### 45 New Keys, woven into the existing Mountain Casitas & Suites, at the Sanctuary Spa and Resort on Camelback Mountain in Paradise Valley

## Responses to focus items in the Statement of Direction

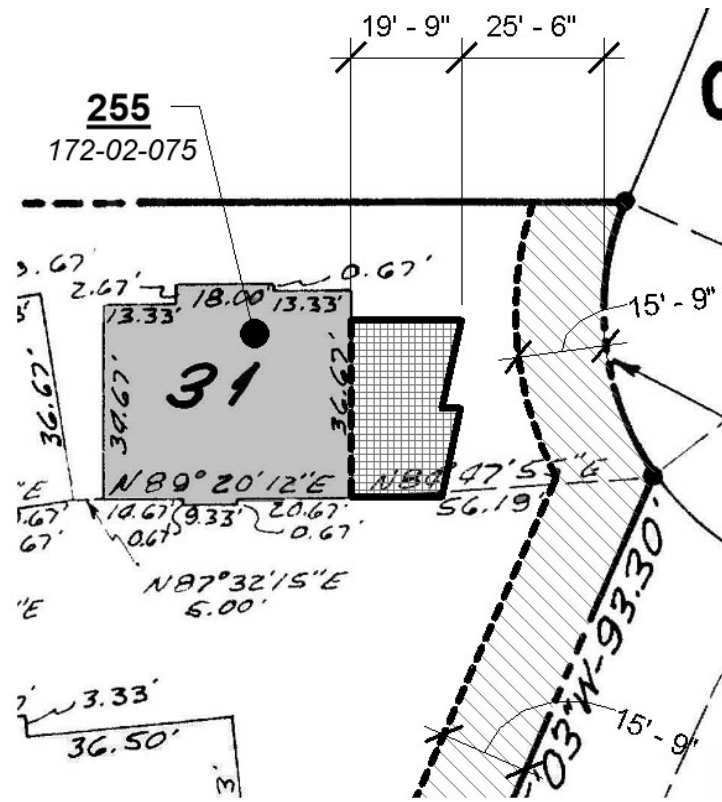
- The project includes a one-story addition to an existing casita. This addition is located on the east side of the project area and is setback approximately 7' from the property line adjoining Starlight Way. Since the SUP Guidelines recommend a minimum setback of 40', the Planning Commission shall review the proposed setbacks.

- *As explained on the attached Setbacks response, the 40' setback does not apply to the casitas area since each casita is located on its own parcel, for which there are no setbacks. However, as also mentioned in the response, distances between property lines can be applied by determined by precedents ranging from 2.61' along common Sanctuary lot lines to 15.75' along roadways. The proposed revised property line for the new one-story addition is more than 25' away from the ROW.*

**2.2)** Hillside casita parcel 31 (172-02-075; Sanctuary Casita 255), lies well within the precedent condition under the current SUP. The proposed improvements are on the east side of the parcel. Currently there exists 45'-3" parcel spacing between the east property line and the Superstition Lane ROW. When the legal description of the parcel is amended to modify the footprint, there would remain a distance more than 25' between new property line and ROW, exceeding the 15'-9" of existing parcel spacing precedent.
